This letter is in response to your request for information dated April 21, 1982 concerning clarification of our previous response dated March 25, 1982.

RESPONSE TO FURTHER REQUEST FOR  
ADDITIONAL INFORMATION

SURRY UNITS ONE AND TWO

12" 10" + 8" RHR

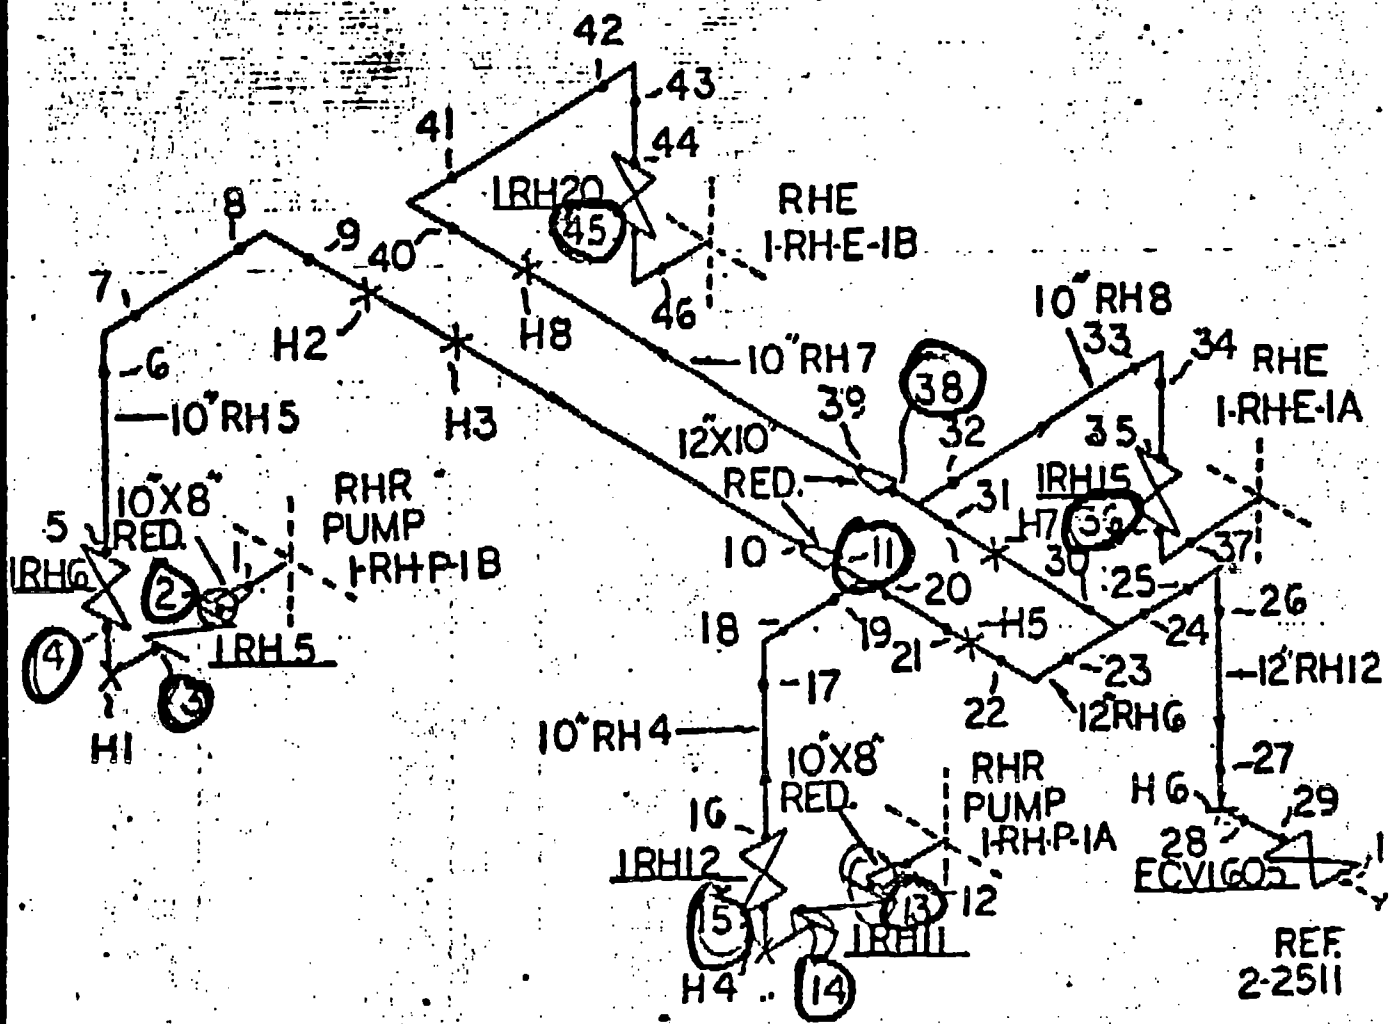
Question 3b

Attached are the sketches showing clarification of welds on the RHR system for items (vi) and (vii) under note II in the unit 1 Relief Submittal.
